# **Temporary Wholesale Trade with Ancillary Storage** for a Period of 3 Years in "Residential (Group D)" Zone, Lot 2339 (Part) in D.D. 130, Lam Tei, Tuen Mun, New Territories

(S.16 Planning Application No. A/TM-LTYY/484)

## **Responses-to-Comments**

FS-01

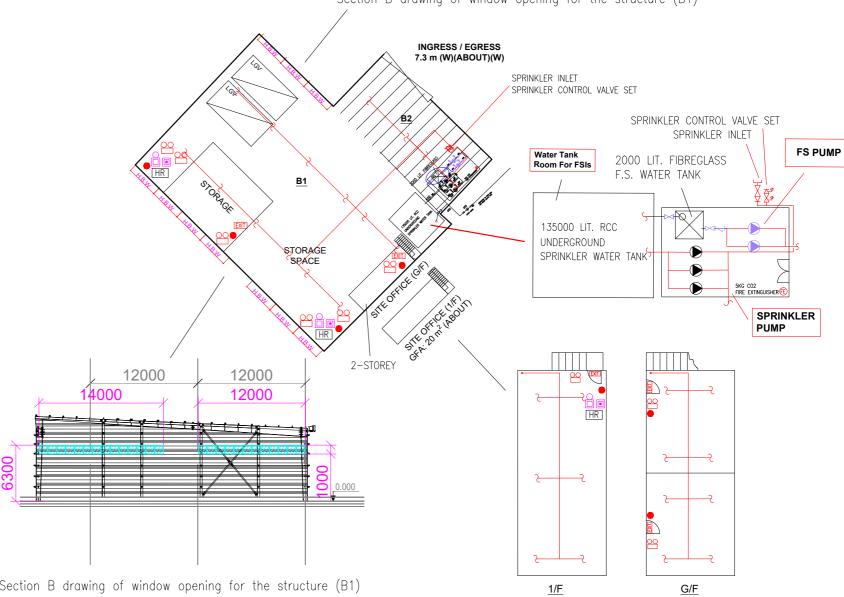
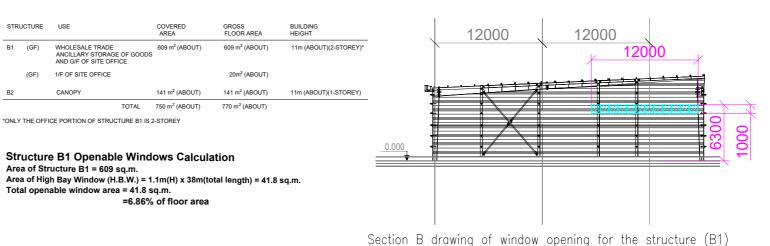
(a)	Emergency Lightning shall be provided in accordance with BS 5266-1:2016, BS EN 1838:2013 and the FSD Circular Letter No. 4/2021;	Noted and revised accordingly (Annex I).

(b)	Sprinkler system, modified hose reel system and fire alarm system shall also be provided to the 2-storey Site Office;	
(c)	The height of openable windows shall be indicated;

(d)	The GFA of site office shall be included in the layout plan; and	
(e)	The no. of storey of Structure B including the site office shall be clarified.
